Our 48th Competition

Block of Three Cottages

Winning Design in our 48th Competition, "Sunset," by F. W. Short, with Mr. A. J. Palmer of Auckland.

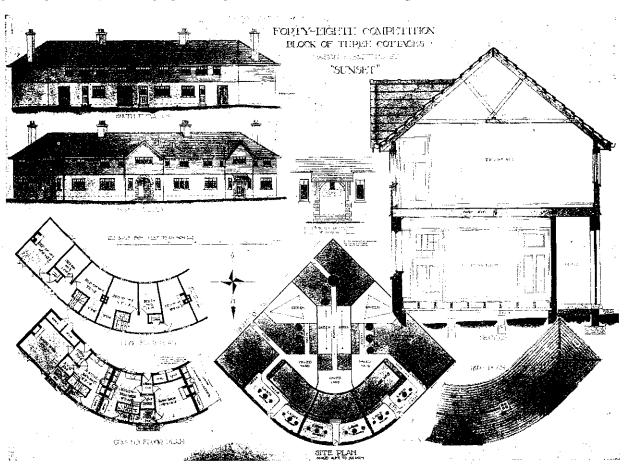
petition, which we place in order of merit as follows, "Sunset," "Hotspur," "Rush." None of the designs are, in our opinion, quite up to the standard of excellence so well maintained hitherto in the generality of these competitions, and although in point of design "Sunset's" contribution has much to recommend it, there are structural anomalies which should not have occurred, but which time, study, and observation will soon eradicate.

As regards "Sunset's" plan, the too intimate inclusion of the w.c. within the building is a mistake. The door enclosing back porch could have been dispensed with, and the porch to centre dwelling could well have been enlarged at the expense of the scullery. Through ventilation to this space is a good feature.
